PRODUCT CHANGE | VEUE WIRE GUIDE TOP TERMINAL

TRANSITIONING.	July 2022

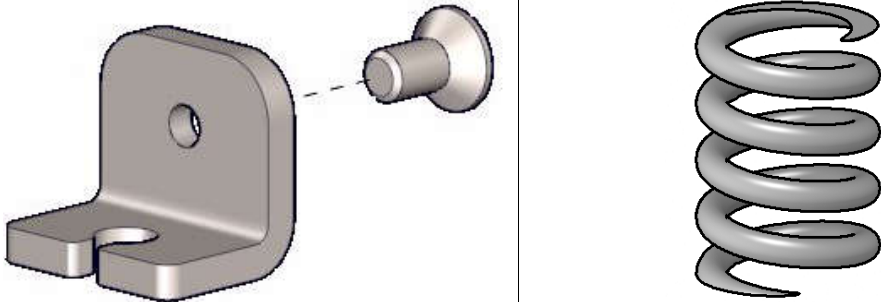
DISCONTINUED PRODUCTS		REPLACEMENT PRODUCT	CHANGES MADE	
	YES	NO			
DESCRIPTION.	Wire Rope Top Hook Saddle Bracket - 304 S/S	Wire Tensioning Spring - 20mm	Wire Guide Top Saddle Terminal Kit w/ Spring	<input checked="" type="checkbox"/>	<input type="checkbox"/>
CODE.	RE24-4002-010032	RE24-9201-009020	RE24-4004-010032	<input checked="" type="checkbox"/>	<input type="checkbox"/>
PACK SIZE.	4 400 Sets	4 800 Pieces	8 200 Sets	<input checked="" type="checkbox"/>	<input type="checkbox"/>
PRICE.	Refer to catalogue.	Refer to catalogue.	Refer to catalogue.	<input checked="" type="checkbox"/>	<input type="checkbox"/>
COLOUR / FINISH.	Stainless Steel	Stainless Steel	Stainless Steel	<input type="checkbox"/>	<input checked="" type="checkbox"/>
IMAGE.				<input checked="" type="checkbox"/>	<input type="checkbox"/>
USE WITH.	Box 120 End Plates, External Open Brackets, Swaged Dome Stud Terminal			<input type="checkbox"/>	<input checked="" type="checkbox"/>

- Conical spring to prevent the Swaged Dome Terminal pulling through under high wire tension.
- Increased tension adjustment range of spring.
- Spring & Saddle Bracket supplied together to reduce SKU's.
- Fastener length reduced to suit thickness of Box 120 & Open Brackets.
- Increased inner pack to 8x sets, reduced outer pack size to 200x sets.
